**HISTORIC LANDMARK COMMISSION**  
**APPLICATION FOR A CERTIFICATE OF APPROPRIATENESS /**  
**APRIL 5, 2023**  
**C14H-1976-0005; HR-2023-031136**  
**WILLIAM PILLOW HOUSE**  
**1407 W. 9<sup>TH</sup> STREET**

Rehabilitate main house and carriage house. Add on to existing nonhistoric addition. Glass in east porch. Create small addition to non-historic carriage house. Add new 6' gate and 4' metal fence to site.

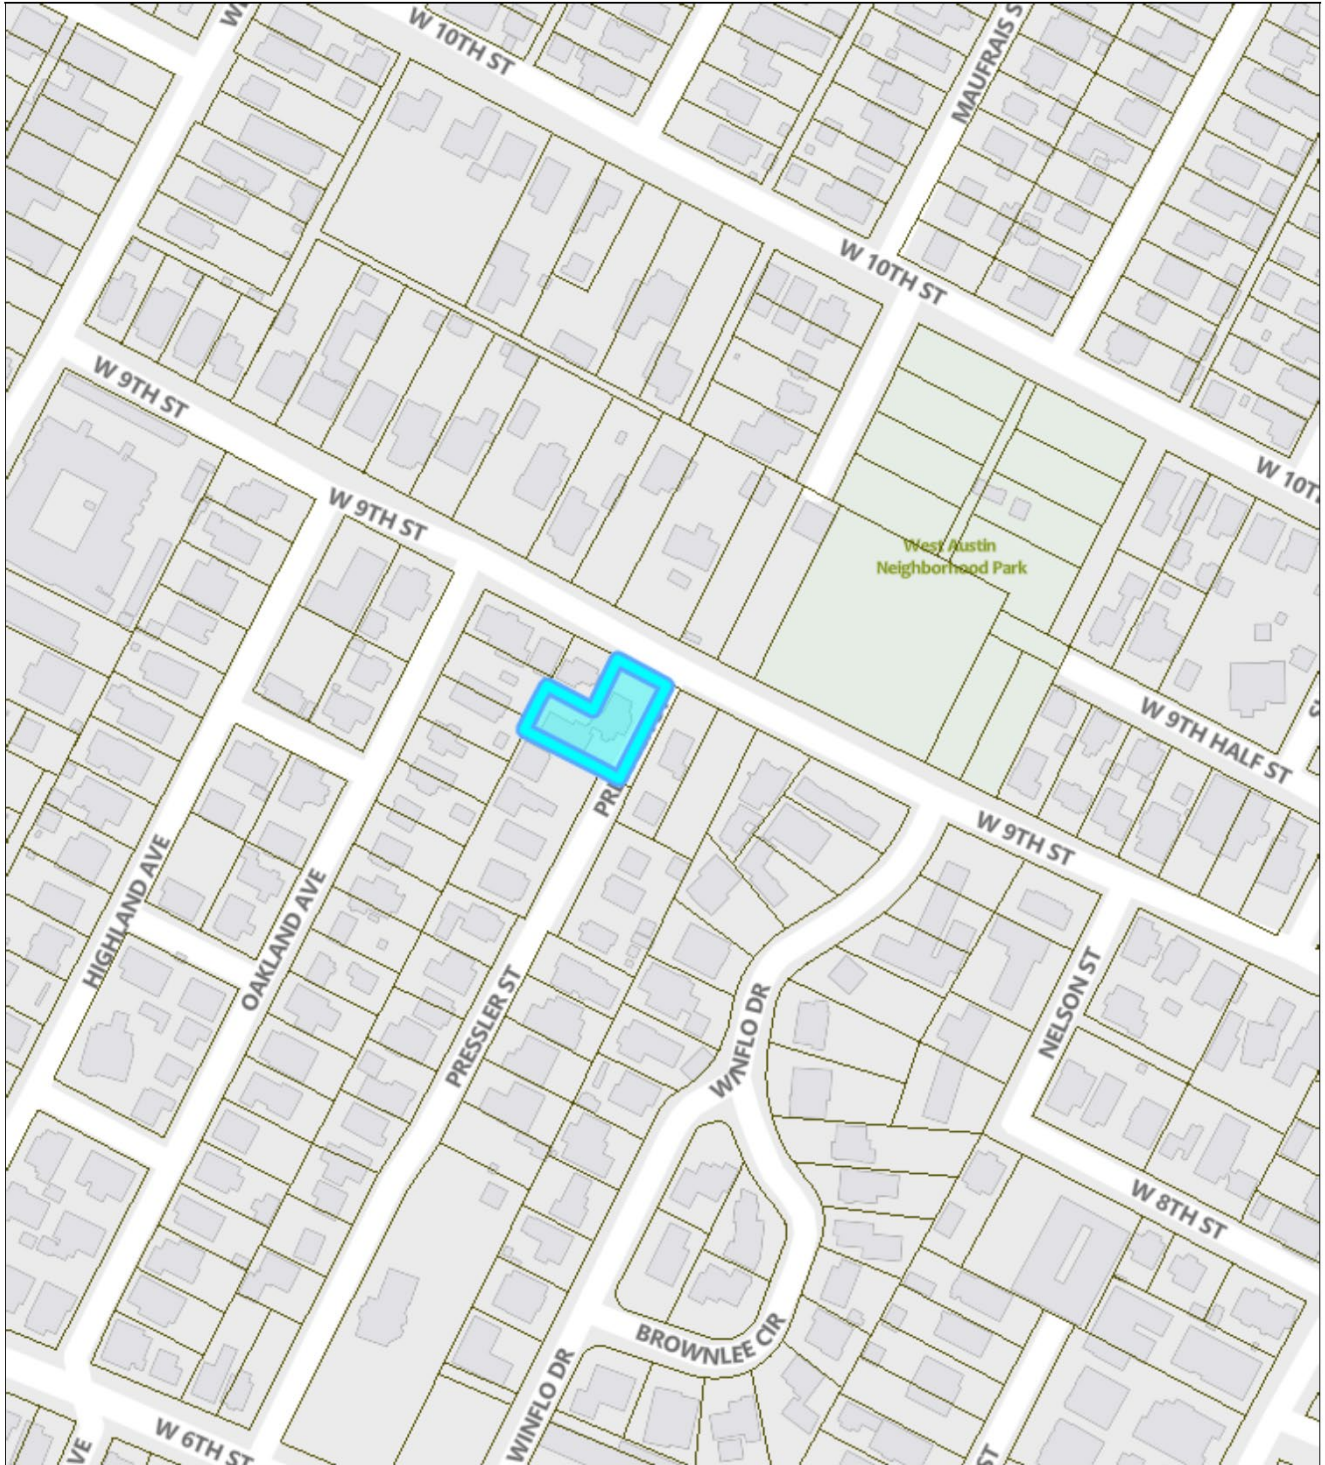
Do not add decorative detail where none previously existed. Use removable panels for porch enclosure or place glass on interior of existing structure.
